CPGF - S - 00000417 - 0

Title: HDKxx Air Bleed Hose Falling Off

Model(s) HDKAH HDKAK HDKAU HDKCA HDKCB HDKCC

Figure 1

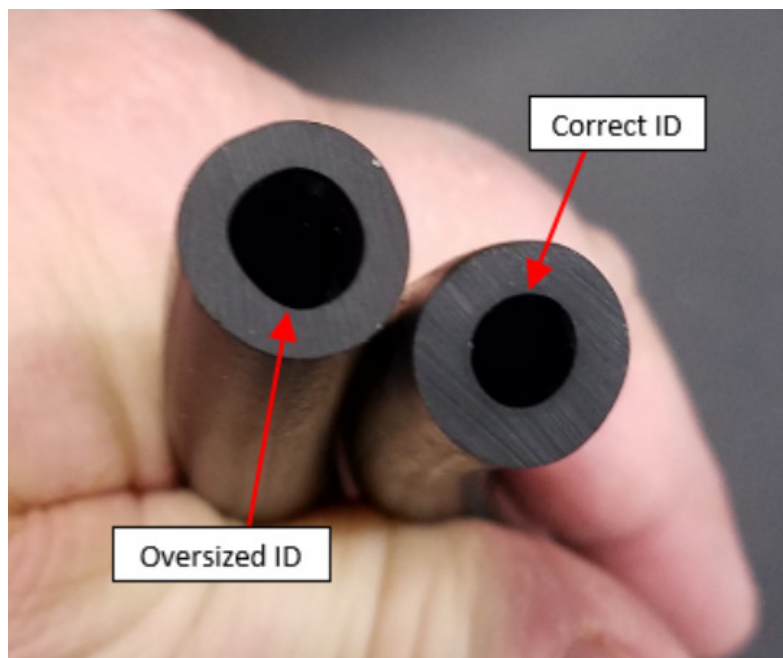
On the generator set models listed above, there is a possibility that part number 0503-1959 (air bleed hose) could have an oversized hole ID (Figure 1), causing it to slide off the tank barbed fitting. Nominal hose ID is $6.3 \pm .8$ mm. See Figure 2 for proper hose connection, and see Figure 3 for incorrect hose fitting, causing the hose to fall off.

If the symptom explained above is found, install hose clamp 0503-0685 at the barbed fitting to keep air bleed hose in place.
